Wastewater Feasibility Study

County Project No. P15-00020

WINERY USE PERMIT APPLICATION REVISION No.4

**RESPONSE LETTER to ENVIROMENTAL HEALTH Division Comments
Mc VICAR VINEYARDS APN 034-160-008**

Existing Septic Field 'As-Built' Plan

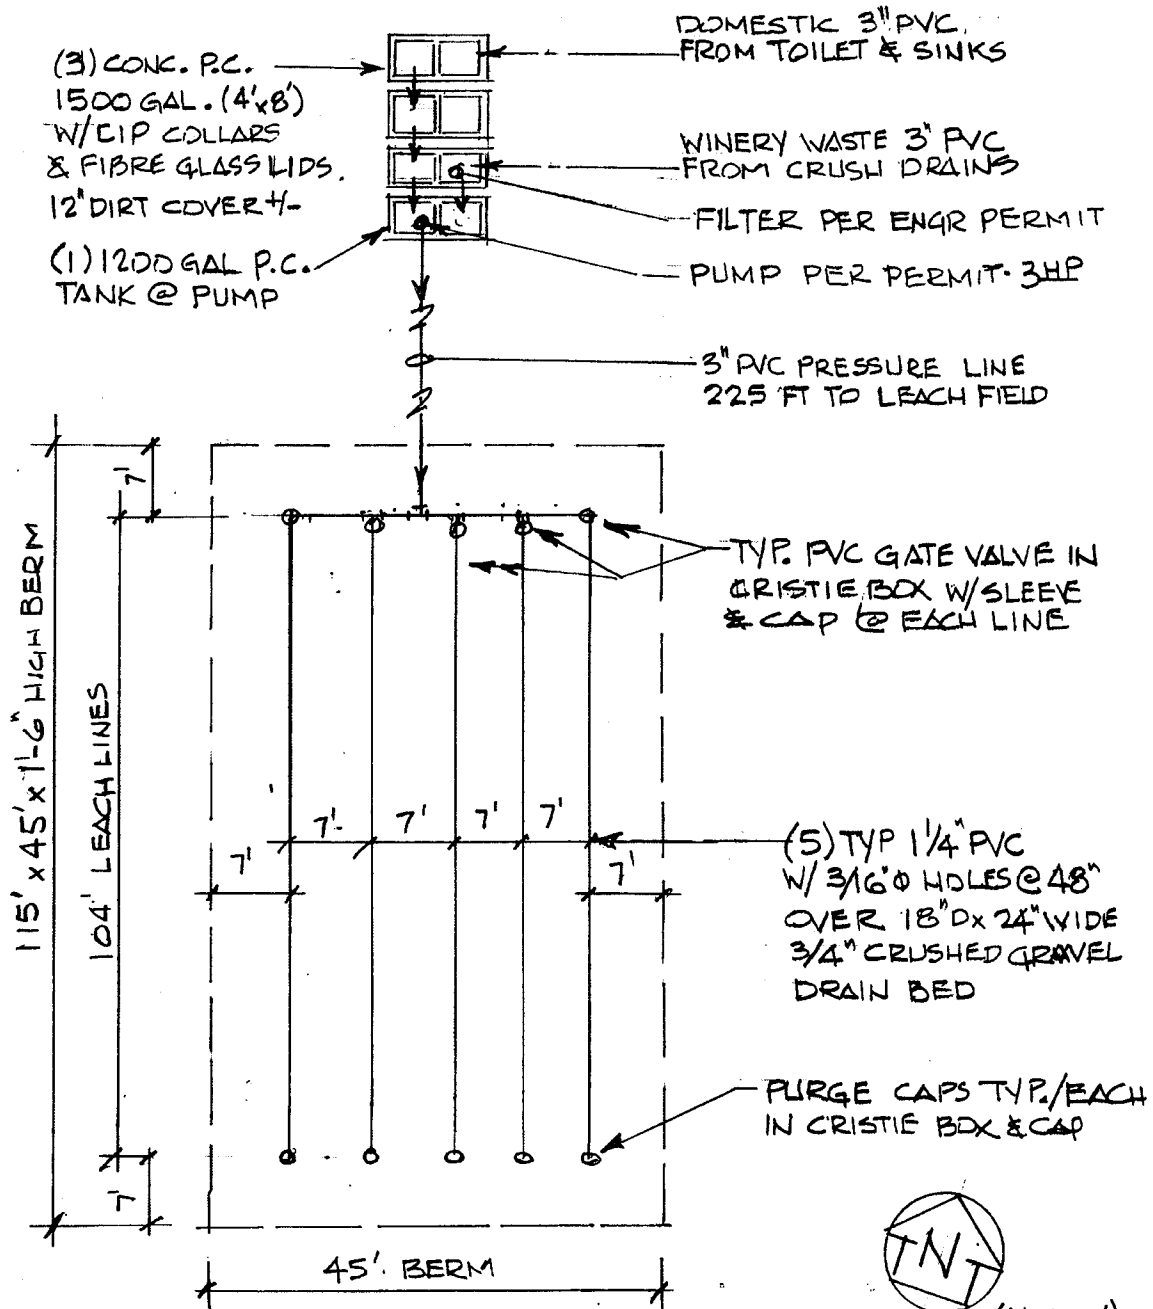
Attached is the Napa County Existing Individual Septic System Inspection Report with all pertinent field-confirmed details and sizes noted. Also attached is an "as-built" drawing (8.5"x11") attached to indicate for the record what is physically existing (overall plan and details) and working in good order.

PRESSURE DISTRIBUTION SYSTEM

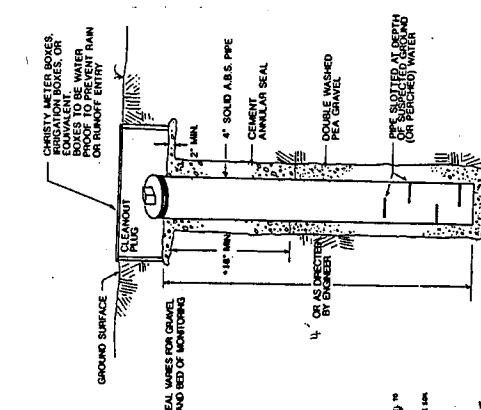
SITE EVALUATION
MADE CLOSE
TO WINEY
BUILDING.
SOIL CHANGES
POSSIBLE?

4/2/92 Spoke with Ted Walker about concerns with plans:

- ① Assumed $\frac{1}{2}$ "/hr. perc. rate
- ② No sand in trenches - only gravel
- ③ Effective area of 4" / lin. ft. as opposed to 2" / lin. ft. as per requirements.

Told Ted that these represent a significant deviation from our guidelines, and as per our agreement with Regional Water, we must refer the proposal to them for review - Ted will write letter to Blair Allen and explain.

Enclosed are revised plans for the proposed small winery mentioned above. Recently, Mark Phillips of P and R Septic, myself and your department have had conversations regarding the design of the wastewater disposal design. Per your request, I have received permission from Blair Allen from the Regional Water Quality Control Board to delete sand from the bottom of the trench in lieu of standard drain rock.

Blair Allen did not give permission to utilize the square footage of the trench bottom in calculating the size of the system. Therefore, this has been modified.

In addition, the recent percolation rate for the area of the proposed system has been estimated at 1 - 3 inches per hour. In my original design, I utilized the most conservative rate allowed at .20 gallons/square foot/day. Therefore, the system can be actually reduced in total size. In dicussing this with my client, he has chosen to reduce the size of the system from the original design.

Using the estimated percolation of 1-3 inches per hour, the percolation rate of 60 minutes per inch converts to .74 gallons per square foot per day. Using the sidewall factor only (liquid area below the pipe), we use .8 feet per lineal foot (for one side), and 1.6 feet per lineal foot (calculating for both sides): Therefore, we use the following equation:

Proposed 550 gallons per day (peak load)
.74 gal/sq.ft./day X 1.6 sq.ft./lineal foot =

550 gallons
1.18 gal./lin.ft. = 466 lineal feet needed

Note: Will install 500 lineal feet for a safety factor.
There is adequate expansion area, the system will be a
Pressure Distribution System, and the trench width will be
24 inches wide instead of 36 inches wide.
